REMARKS/ARGUMENTS

In the April 21, 2005 Office Action, the Examiner rejected Claims 1-3, 6, 8-9 under 35 USC § 102(e) as being unpatentable over Harumoto (US Patent No. 6,460,097); and Claim 4-5 under Iwasaki (US Patent No. 6,198,876). The Examiner also rejected Claims 7 and 10 under 35 USC § 103(a) over Harumoto in view of Iwasaki. Applicants thank Examiner Casiano and Primary Examiner Gaffin for the telephone interview that was conducted on June 16th, 2005, and a summary of the interview is provided below. Applicants have amended Claims 1-2 and 4-7, 9-10, cancelled claims 8 and 11, and added new Claim 12. Claims 1-7, 9-10 and 12 are now pending of which Claims 1, 4, 6 and 9 are independent claims. Applicants respectfully request reconsideration of the patentability of the claims of the present application in view of the amendments and the following remarks.

FIGURE 1B

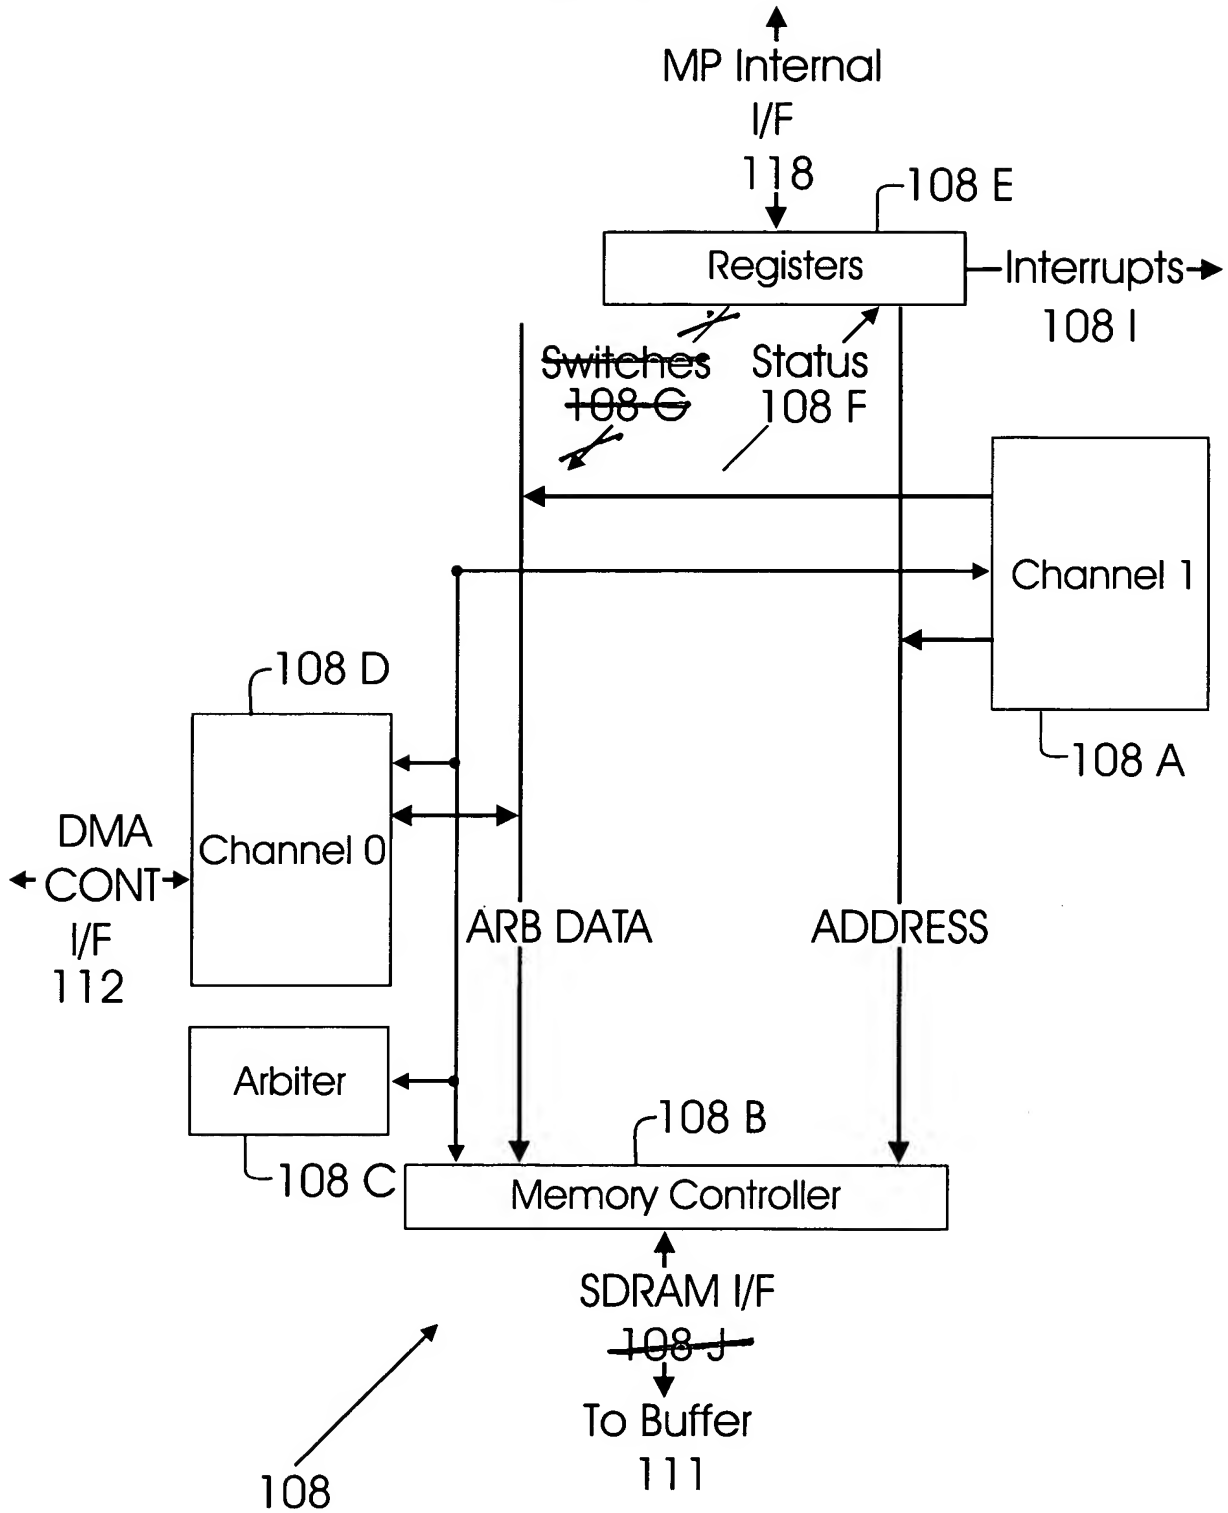
Figure 1B: 108J, 108G, 108I and 108F

Applicants have amended paragraph [0038] to reference 108F and 108I in the specification. Applicants also submit substitute Figure 1B where reference to 108J and 108G has been removed.
